**DEVELOPMENT CONSENT AUTHORITY  
DARWIN DIVISION**

**AGENDA ITEM:** **2**      **MEETING DATE:**    04/04/2025      **FILE:** PA2025/0044

**APPLICATION PURPOSE:**    Data Centre with ancillary office in a 7-storey building

**SUBJECT SITE:**                Lots 9703 (6) and 9704 (2) Ryko Court, Darwin City,  
Town of Darwin (**Bookmark A**)

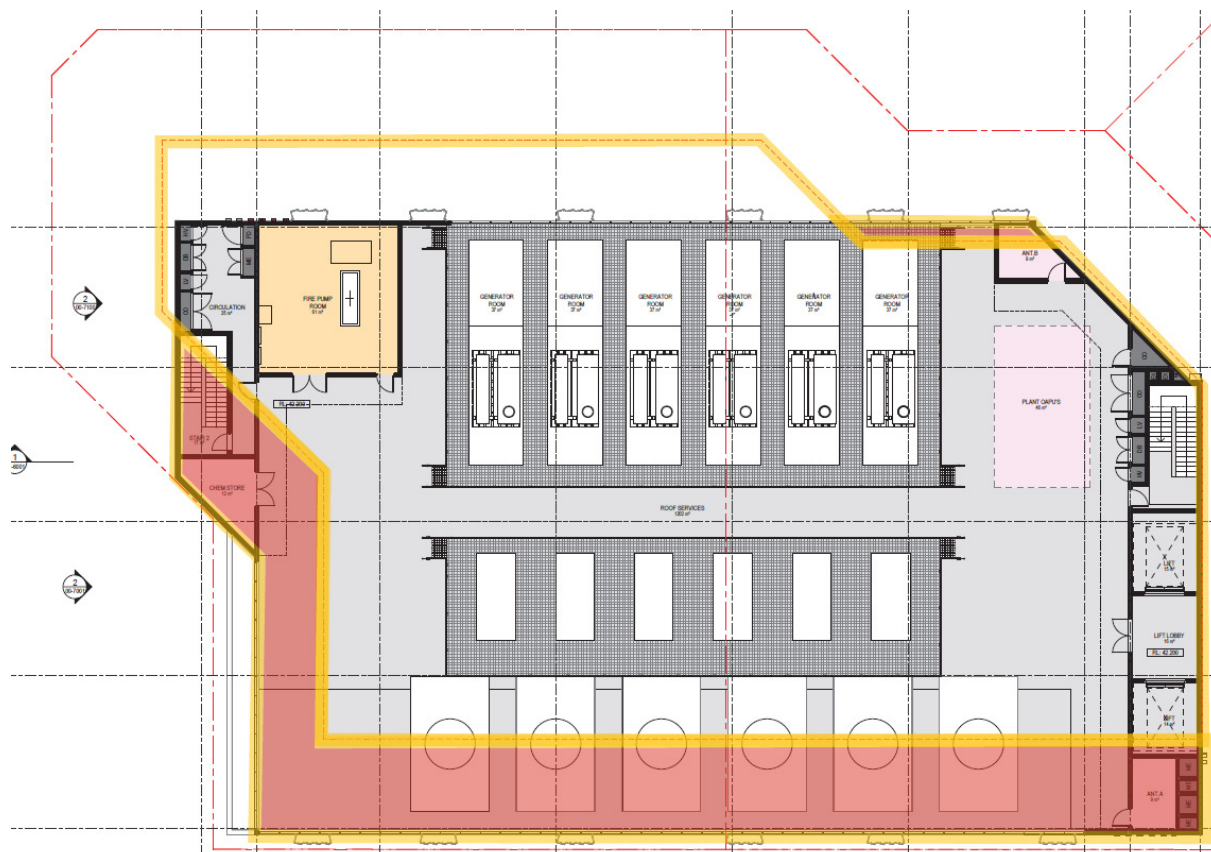
In response to sub-clause (a), it is noted that the upper ground level provides approximately 22 m of full height windows that overlook Ryko Court (albeit some are semi-obscured by external fire tanks). Although these dimensions are not active street frontage, they're considered to provide some passive surveillance of the public domain. In addition, it is considered that the proposed inclusion of 2 styles of garden beds along the Harvey Street and Ryko Court property boundaries will aide in creating an attractive streetscape.

In response to sub-clause (b), it is considered that the locality of the development site is the area bound by McMinn Street, Day Street, the former railway reserve, and Garramilla Boulevard, and which is located on the periphery of the Darwin CBD. A review of the town planning history for this locality identified the area as being generally zoned for light industrial uses in 1966, highway commercial/special purpose (electrical substation) in 1978, highway commercial/community purpose (electrical substation) in 1992, and central business in 2007 and 2020. Although the existing locality comprises limited residential development (with varying levels of active street frontage), the majority of the area is high security fencing (such as a 170 m length along Harvey Street associated with the electrical substation site), light industrial)/commercial developments along the McMinn Street service road, or otherwise undeveloped lots. As such, the limited active street frontage proposed in this development is not considered to be inconsistent with the existing character of this locality.

In response to sub-clause (c), the provision of separate and dedicated accesses to essential services from the public domain are considered to be necessary for their operation, maintenance, and accessibility in the event of an emergency.

Based on the above discussion which takes into account site specific constraints and this particular locality, the proposed variation to clause 5.5.16 (Active Street Frontage) is acceptable, as although the proposal includes limited active street frontage, this development would improve the activation of the street by the provision of landscaping, and additional day time uses in the area.

However, it is considered that the consent authority may want to seek clarification from the applicant as what discussions have taken place with relevant service authorities, that would reasonably preclude the potential for services to be integrated, and/or co-located together. It is further noted that the consent authority may want to query why the provision of a balcony facing over Ryko Court is no longer proposed. Although this element is not active street frontage, it would improve passive surveillance of the public domain.

Red shading indicates area in breach of the 6 m setback on an typical level (level 5 shown)

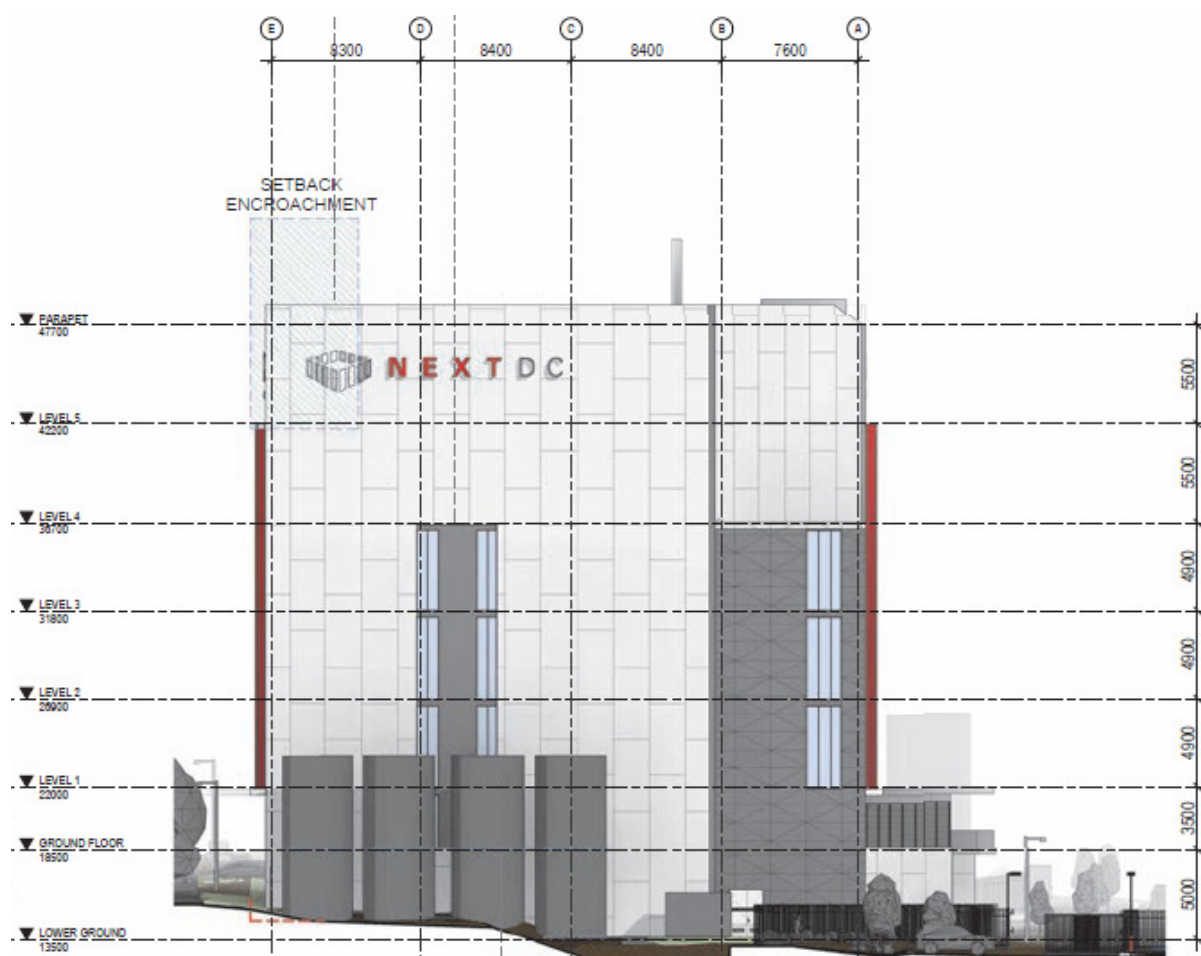
Sub-clause (6) requires that *The tower of a development is to: (a) have a footprint that covers a maximum of 56% of the site area, to a maximum of 1200m<sup>2</sup> in any single tower; (b) have the length of each side of the tower be no more than 75% of the length of the adjacent boundary; and (c) provide minimum setbacks of: i. 6m from any site boundary; [...], where (a) the application proposes the tower component will be 65% of the site area; (b) the length of the tower facing all property boundaries exceeds 75%, and (c) the development will be located within 6 m of the property boundaries fronting Garramilla Boulevard, Harvey Street, and Ryko Court.*

In response to sub-clause (a), it is considered that a variation to the volumetric dimension is acceptable, as the subject lot is located at a gateway location, and a variation to the Garramilla Boulevard/Harvey Street frontage would help visually distinctive built form for people entering the Darwin CBD via Garramilla Boulevard.

In response to sub-clause (b), as the development site is bounded by three public streets, and another property with an existing data centre, this application is not considered to reasonably restrict the future development of other properties in the area.
